# CERTIFICATE OF APPROPRIATENESS APPLICATION FORM

Brewers Hill

1933 N 1st St Milwaukee, WI 53212

**Brewers Hill Inquiry**

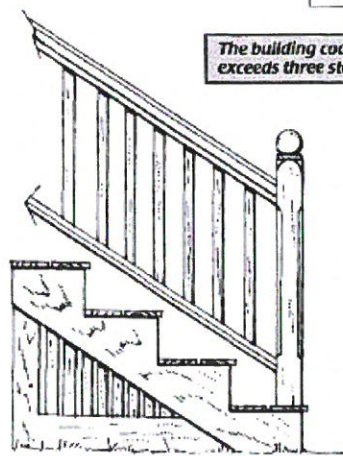
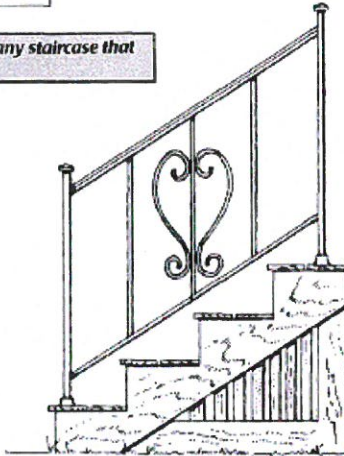
Yes it does require a Certificate of Appropriateness. I've attached a photo of the kind of style we typically recommend.

Below see a typical design that is not approved. Please avoid curlicues such as in the "No" image.

I understand. We still review that. The guidelines we have don't specifically address sidewalk/berm steps. If you were to rebuild those sidewalk steps, state building code would require a handrail anyway. Metal railings are perfectly fine for the situation you are describing. I just need to see the design. The "no curlicue" thing stands for either kind of outdoor stairs.
